Nomination Form Anadromous Waters Catalog

112-42-10160-2021-2003

DELETION

Cc: <u>Giefer, Joe (DFG)</u>
Subject: RE: Corner Bay Stream

Figure 1.-112-42-10160-2021-3003 deletion map.

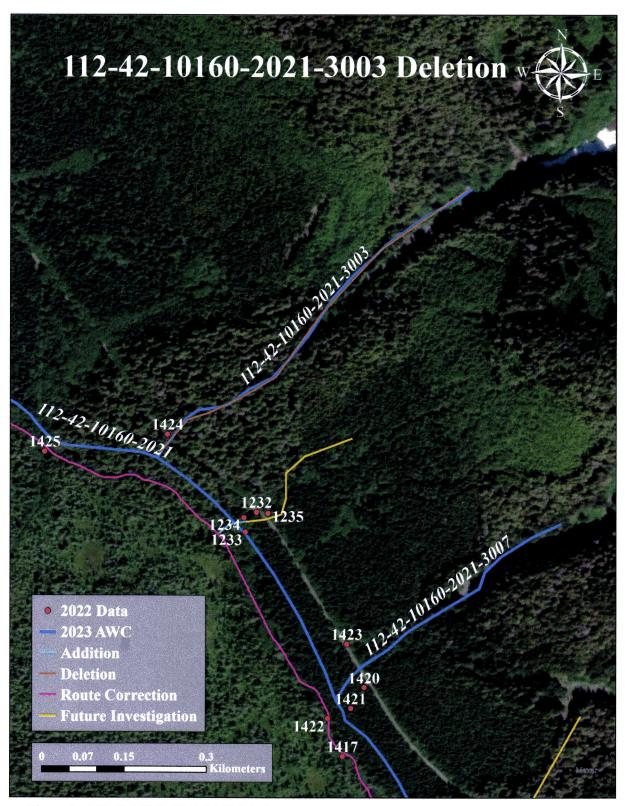
Findings: We surveyed this cataloged stream at the road crossing and found no stream exists. Please delete this stream upstream of the road crossing at waypoint 1424 (Table 1; Figure 1). **Recommendations:** Delete Stream No. 112-42-10160-2021-3003 in the anadromous waters

catalog (Figure 1).

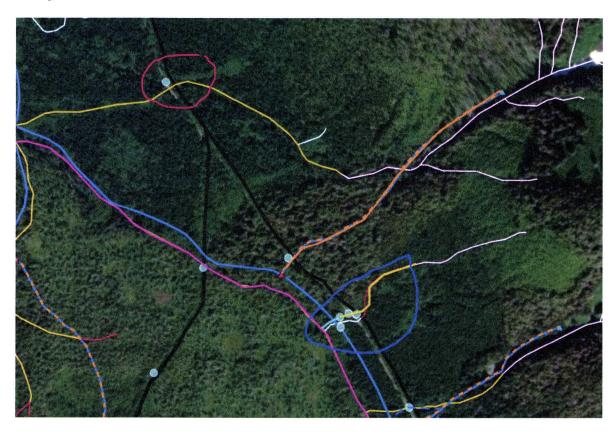
I hope you are enjoying the tail end of summer. While submitting nominations in corner bay we decided to delete a cataloged stream (112-42-10160-2021-3003). We looked for the channel in 2022 and this summer and couldn't find it in the original spot that the AWC has it (orange line with a blue line behind it in the pic). According to your stream layer it looks like it goes north to the channel circled in red. When we looked at that in 2022 it was abandoned. Any idea where the water from this valley goes? My thoughts are either subsurface or into a new channel just to the south (circled in

blue).

That whole clump of old growth is an alluvial fan, so it likely has switched to the blue circled area if the other two are dry.

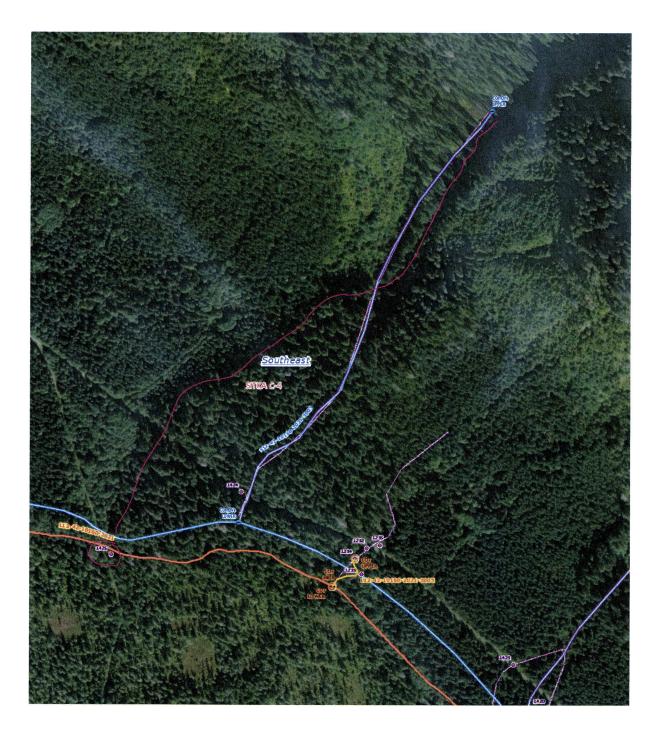
Stream was proposed for deletion because the road crossing wasn't where it's shown on the map but I think the hydrography is probably way off as its also unsubstantiated. Waypoint 1425 in your data from 2022 would seem to be in the approximate location of the mouth too, but no mention in the notes there.

The terrain here clearly shows some water coming out of the upstream valley, but I think the mouth is likely way off, maybe even dispersing under the heavy vegetation. Most recent GEI is 2019 and shows water too.

Red line is where I would speculate stream is more likely aligned based on topography.

Sorry for the delay. We didn't see any signs of a channel there. I will ask the FS folks who go out there frequently. Its possible all that water goes subsurface. We found a lot of losing streams in that area.
